AGENDA
Design Review Committee
December 8, 2021 – REGULAR MEETING
5:00 PM

Town of Jackson Design Guidelines Checklist

Item Number: P21-082

Address: 105 E. Broadway Avenue

DRC 3

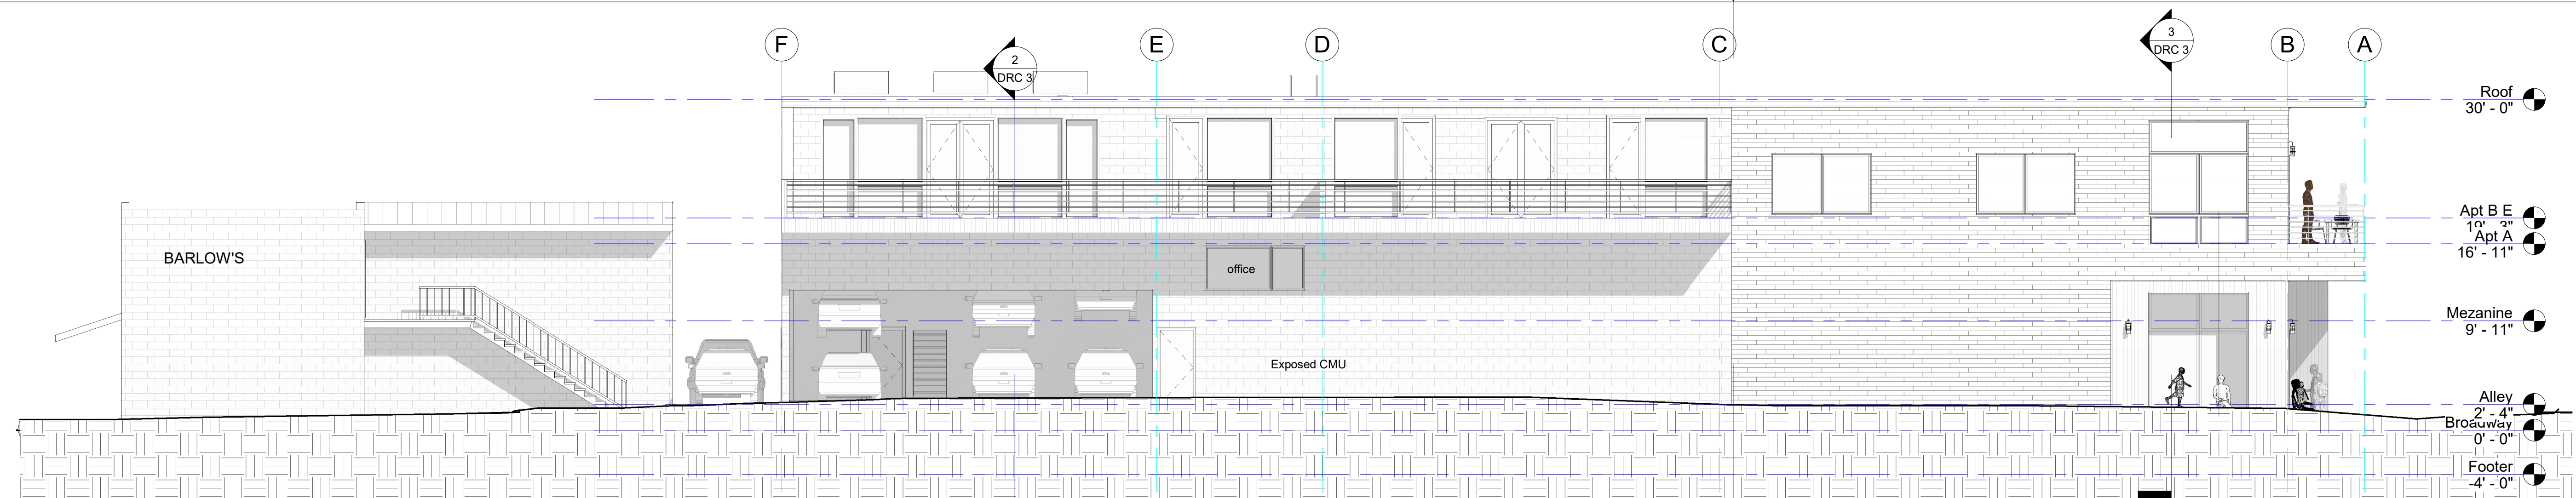
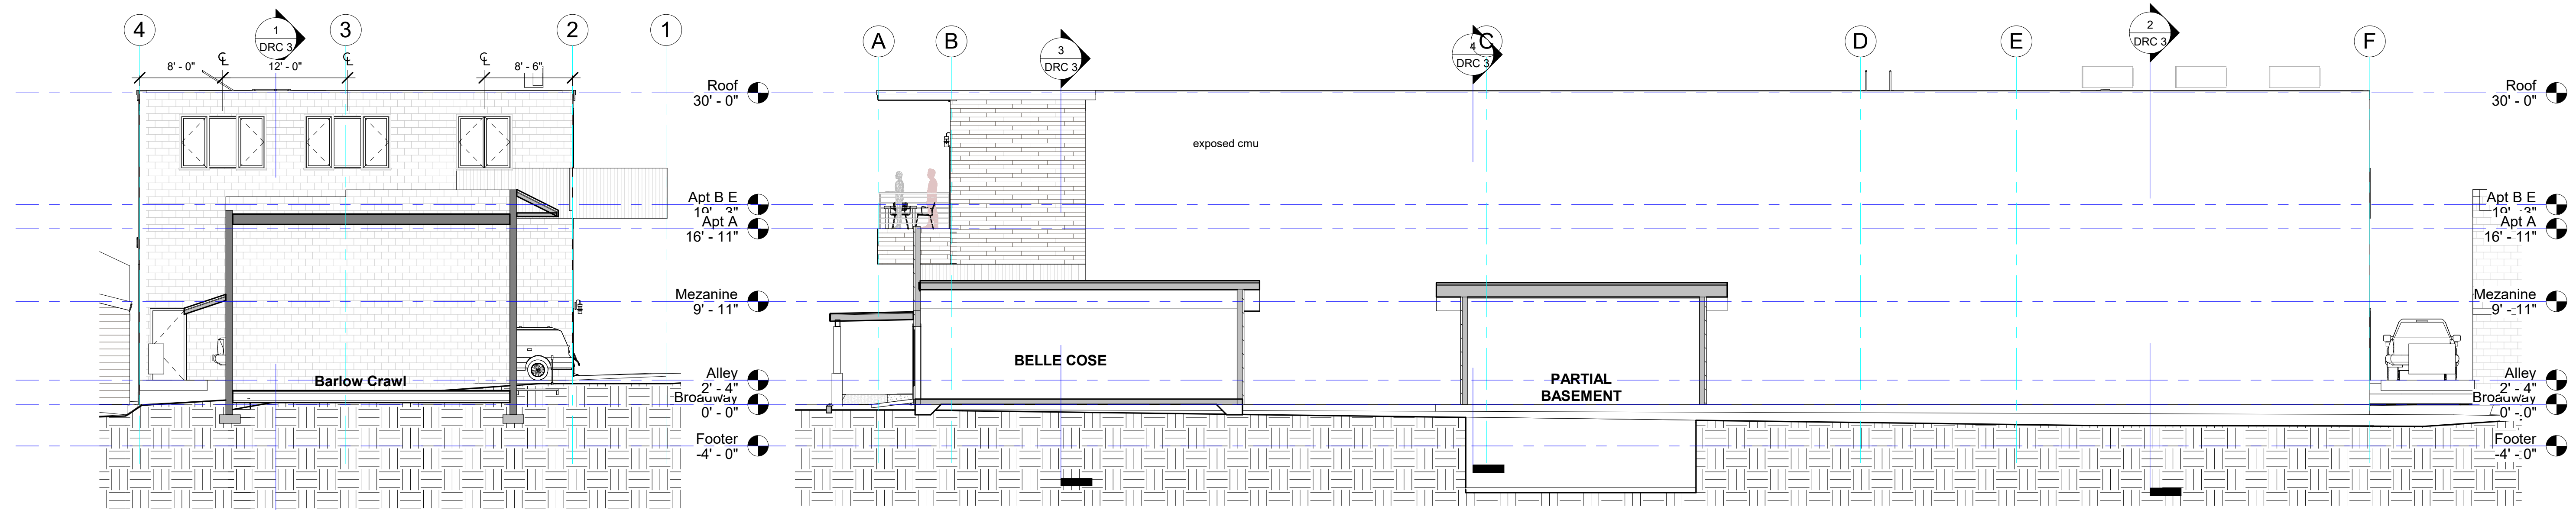
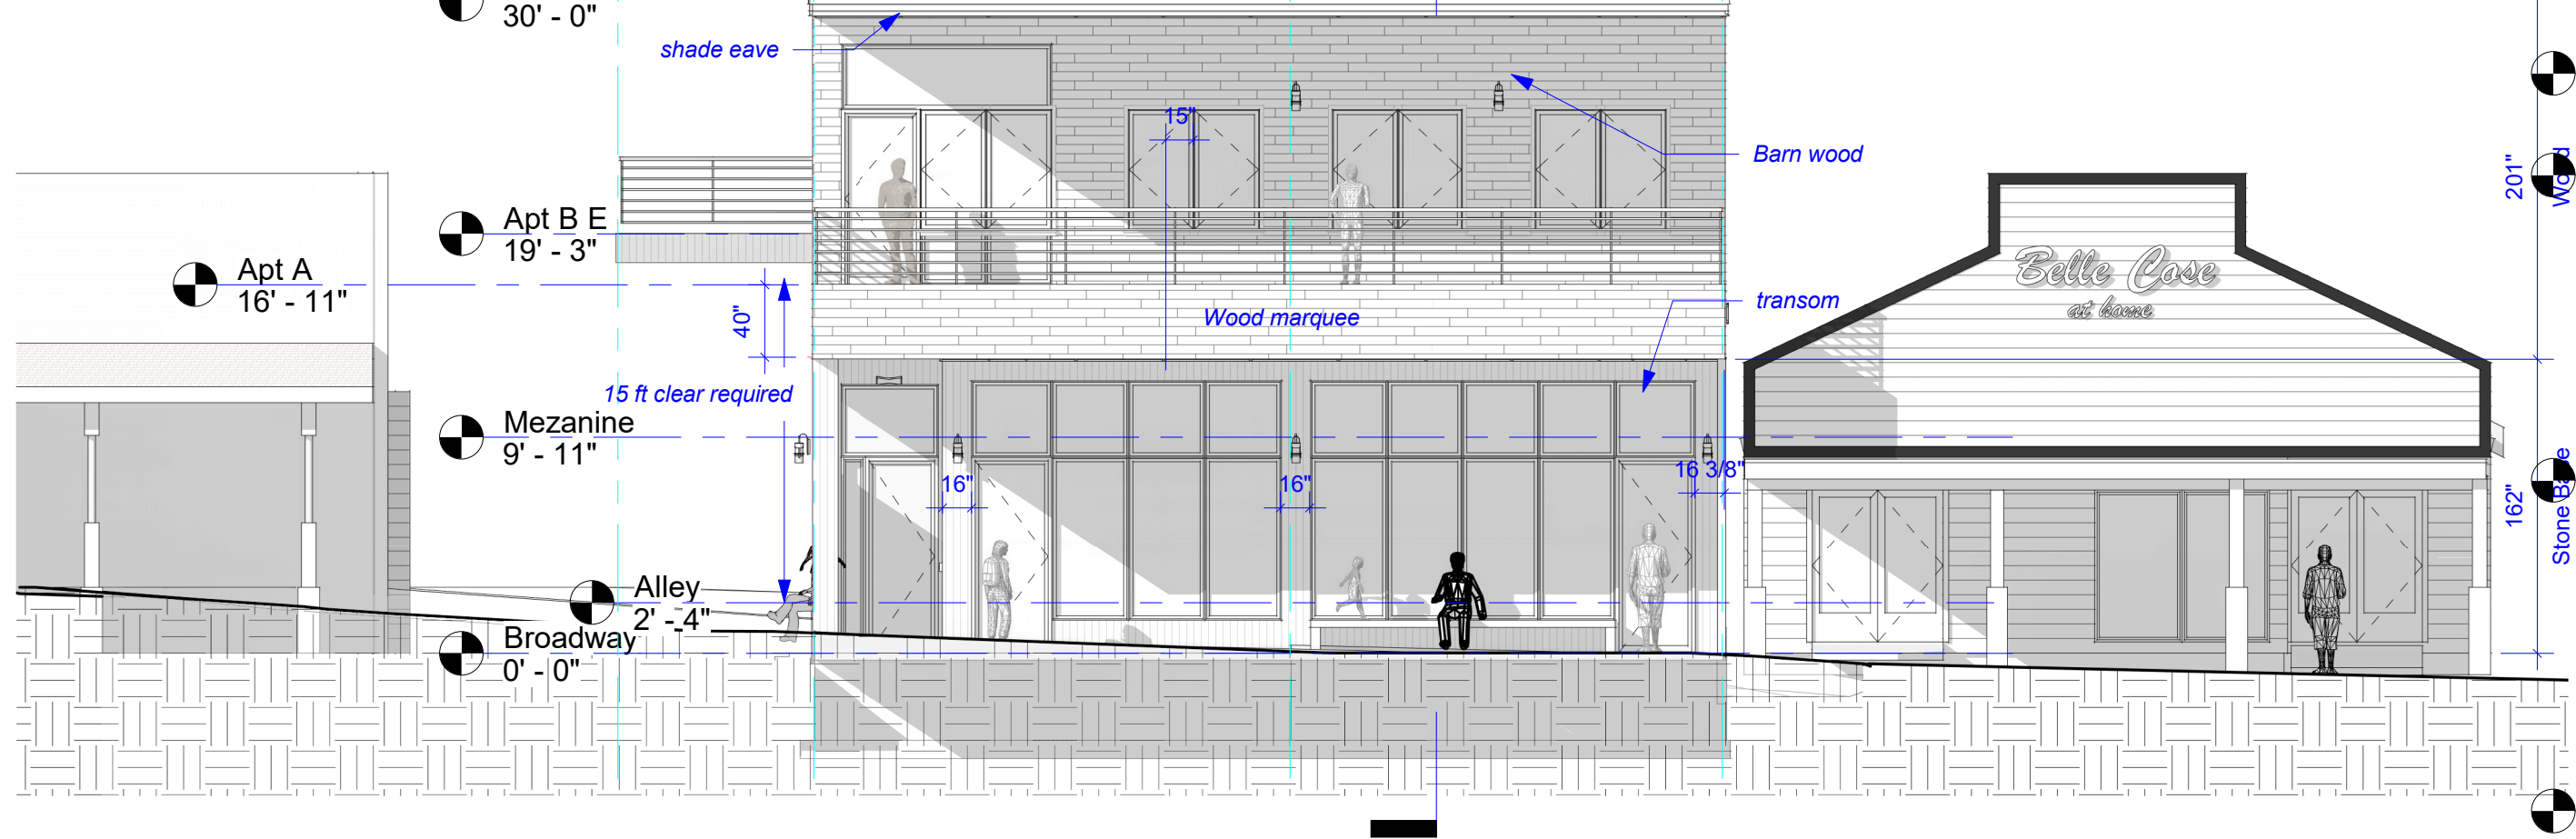
- The spacing on the upper floor roof brackets needs more balance. The DRC suggested that the applicant either correct the spacing on the brackets or remove the brackets altogether.
- The spacing and configuration on the upper-level windows lacked consistency and harmony. The applicant should seek to simplify the types of windows to be more uniform.
- The ground-level bench seemed counterproductive to the retail space on the ground level as it created a viewing barrier. The applicant needs to revisit this element and consider reducing or removing the bench.
- The 3D models did not accurately represent the proposed materials/colors. The applicant should provide better 3D renderings.
- The applicant should include a stone band around the windows on the lower level because the stone feels out of place in the proposed locations.

We eliminated brackets at the South porch/ cornice. High forehead or blank areas above windows, though extremely common in traditional architecture, are mitigated with sconces

Planting are eliminated, the south bench is reduced, and a bench is added at the southwest porch. We think these elements are friendly, yet not gratuitous.

West Alley Balconies revised to a single, consistent depth. This does not adversely effect the Broadway facade.
